SAN FRANCISCO PLANNING DEPARTMENT

MEMO

DATE: August 23, 2017
TO: Planning Commission
FROM: Melinda Hue and Rick Cooper, Environmental Planning
RE: Errata to the Environmental Impact Report for the
Pier 70 Mixed-Use District Project
Planning Department Case No. 2014-001272ENV

REVISIONS TO THE IRISH HILL PASSAGEWAY VARIANT TEXT AND FIGURES (RTC pp. 2.16-2.27)

(NEW) FIGURE 6.1: IRISH HILL PASSAGWAY VARIANT
 * Note: Revised to include a new site plan for the Irish Hill Passageway Variant.

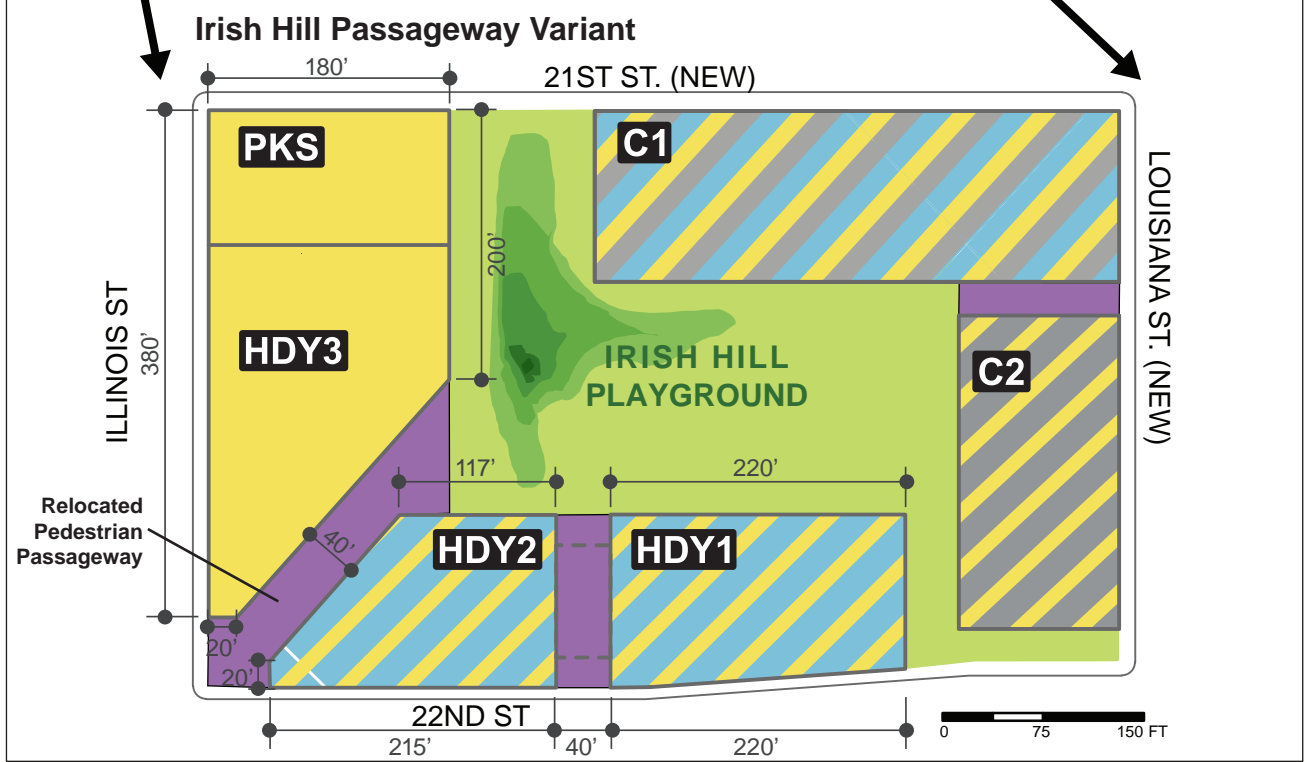
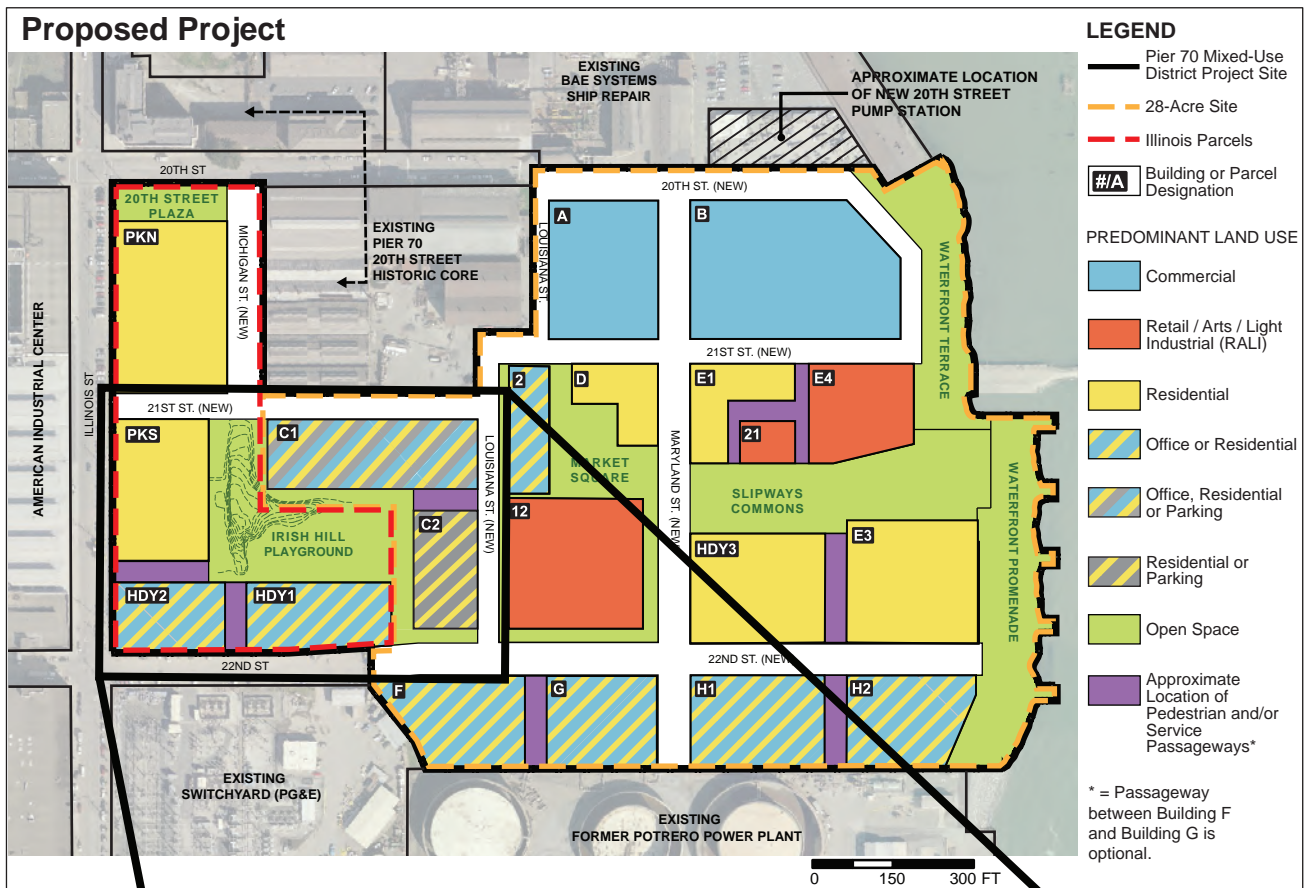
Under the Irish Hill Passageway Variant, the pedestrian passageway would be shifted southward northward by approximately 165 feet to the corner of Illinois and 22nd streets, and would bisecting Parcel HDY2, creating a new Parcel HDY3 adjacent and to the south of Parcel PKS (which would become PKS1 and HDY3 with this variant), and would widen from 40 feet at Illinois Street to 55 feet at Irish Hill Playground, to allow views of the southern and western faces of the Irish Hill remnant ~~from Illinois Street~~. (See Figure 6.1: The Irish Hill Passageway Variant.)

As such, this variant includes only minor changes to the configuration of infill construction within Parcel PKS and HDY2. Under this variant, the relocated pedestrian passageway would bisect Parcel HDY2, creating a new Parcel HDY3 adjacent and to the south of Parcel PKS, ~~and new construction within the southern portion of PKS (now HDY3) would abut new infill construction within Parcel HDY2 to the south.~~
